# GOODFIRE PARKING EXPANSION

# SITE PLAN AMENDMENT APPLICATION

Subject: Comment Response Letter  
Goodfire Brewing Parking Expansion – Freeport, Maine

On behalf of MR 117 Route One, LLC, we are pleased to respond to the comments that we received from Gorrill-Palmer as part of the Site Plan Amendment peer review.

STABILIZED CONSTRUCTION ENTRANCE NOT TO SCALE

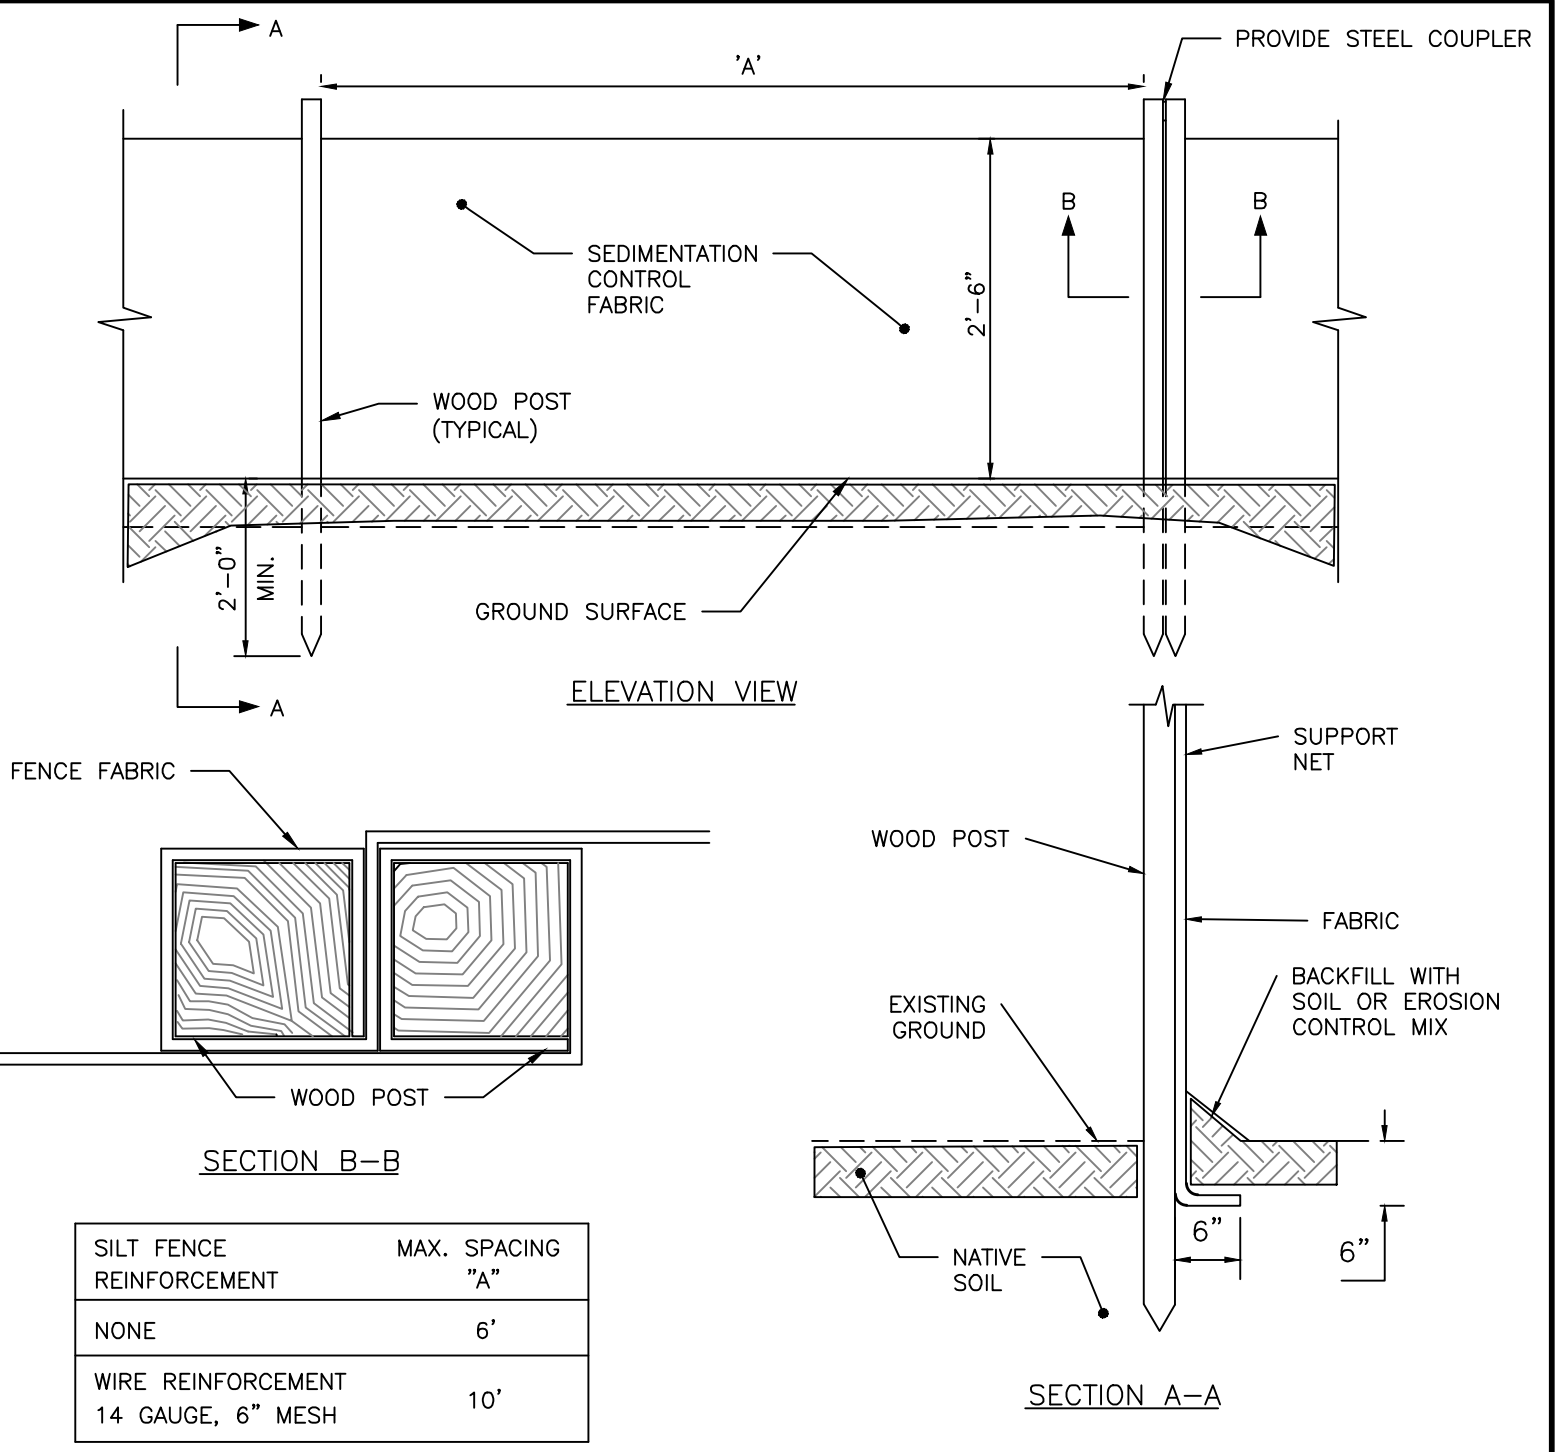
**Comment** – *Show a construction entrance on the erosion control plan.*

**Response** – A potential construction entrance has been added to the erosion control plan if deemed necessary at the time of construction. It should be noted that the site contractor will likely utilize the existing curb cut which features a paved/stabilized entrance.
